BEFORE THE UTAH PUBLIC SERVICE COMMISSION

DPU EXHIBIT 11.0
DOCKET No. 09-035-23

Pre-filed Direct Testimony

William A. Powell, PhD

187 **Figure 1: Forecast Error Distribution, Wolverine Creek**

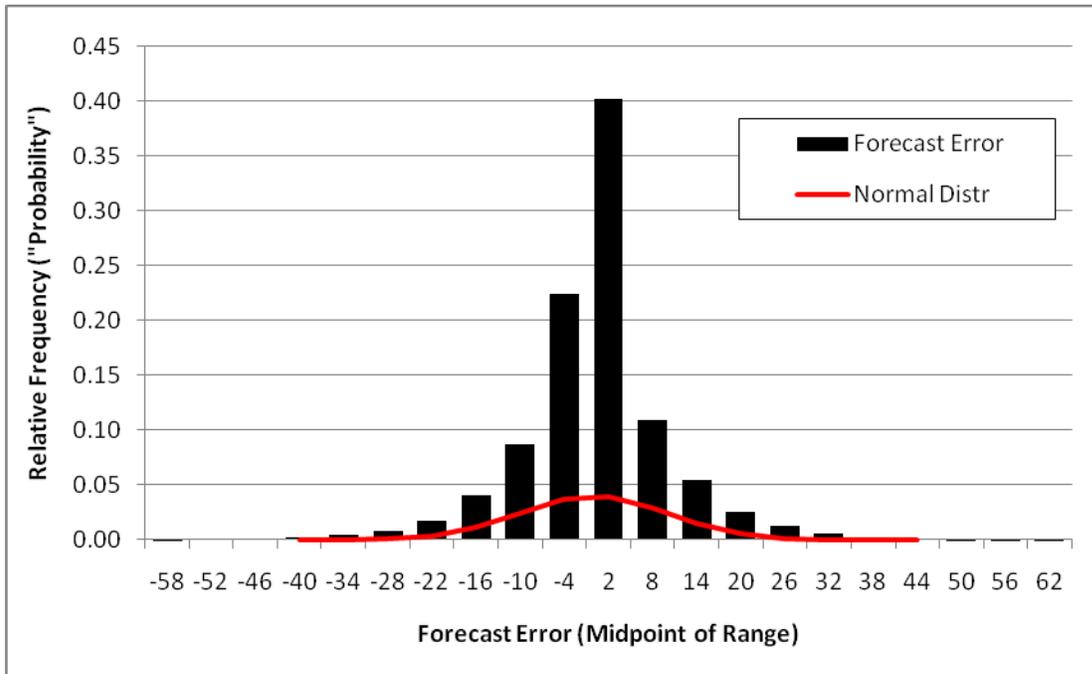
178 A: Yes. I used the sample data for Wolverine Creek from the Company's WIC study
179 to construct a histogram, or an estimate, of the distribution for each of these
180 elements. In each case, the histogram reflects the conclusions drawn from the
181 summary statistics. The relative histogram for the forecast error is in Figure 1. In
182 this graph for the forecast error, I have also superimposed a comparable normal
183 distribution, a normal distribution with the same mean and variance as the

184 forecast error. As can be seen in the graph, the distribution for the forecast error,
185 while relatively symmetric around the mean, is significantly more peaked than the
186 normal distribution.

193 **Figure 2: Regulate-Up Distribution, Wolverine Creek**

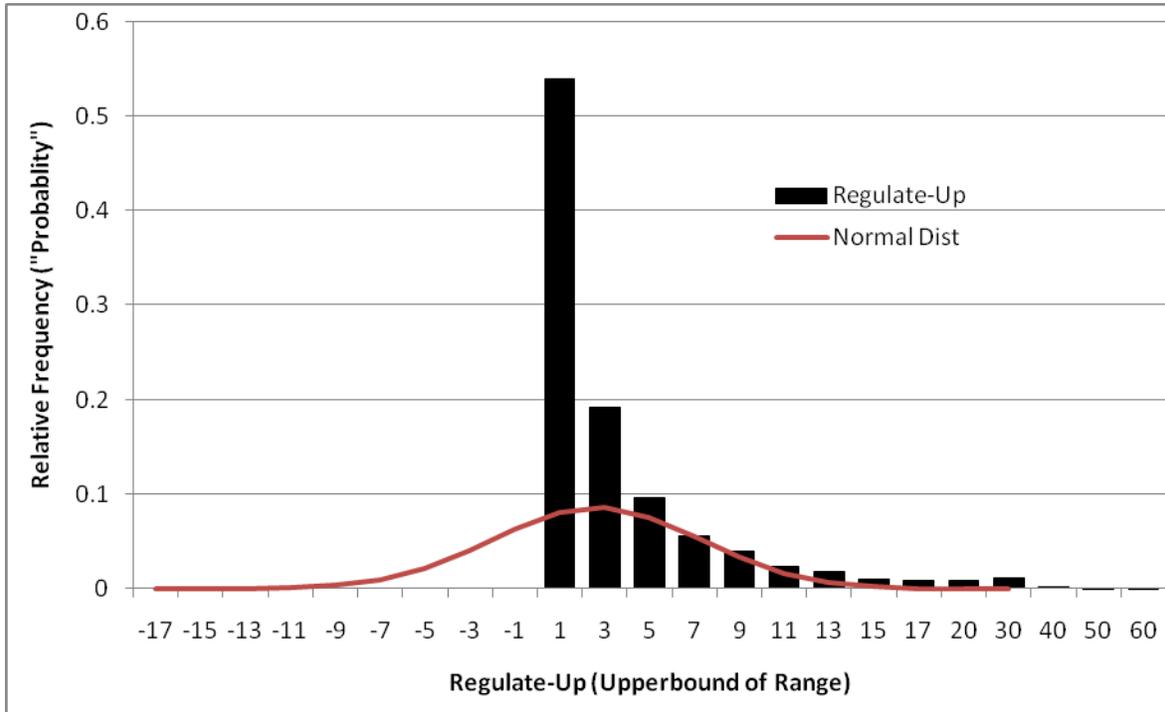
189 A similar depiction of the relative histogram for the regulate-up element
190 for Wolverine Creek is shown in Figure 2. Again, the histogram supports the
191 conclusions drawn from the summary statistics. The distribution is considerably
192 skewed to the right and more peaked than the normal distribution.
